# Access Compliance Report

## Public Rights-of-Way

### (Pedestrian Signals)

Intersection ID: N/A	Main Street:	Cross Street: N/A	Location: N/A
ADA ID: 5362B2DA7644	Signal Type: One Push Button-APS	Overall Compliance: No	Severity Score: BTN 1: N/A BTN 2: N/A No BTN: N/A
Codes/Mitigation Info/Possible Solution		Field Measurements/Component Compliance

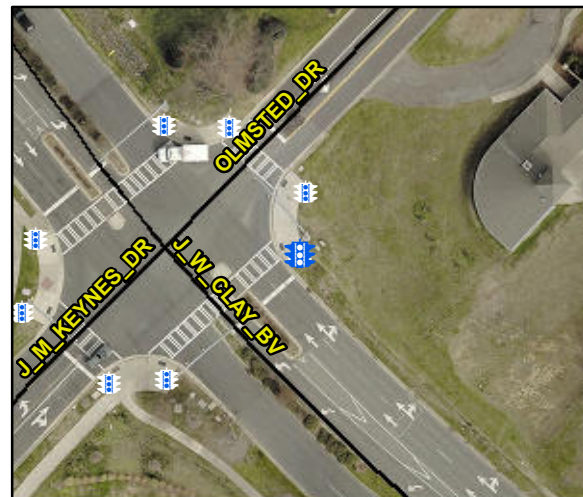
Surveyor Notes: NOT HOOKED UP, NOISES AND VERBAL COMMANDS UNKNOWN

PROW/ADA: TMUTCD 4e.08, R404.2, R404.3, R404.7.2, MUTCD 4e.08, R104.2, R209.1,

Possible Solutions: Replace Signal Push Button With APS Button on New Post. Remove & Relocate Sign.
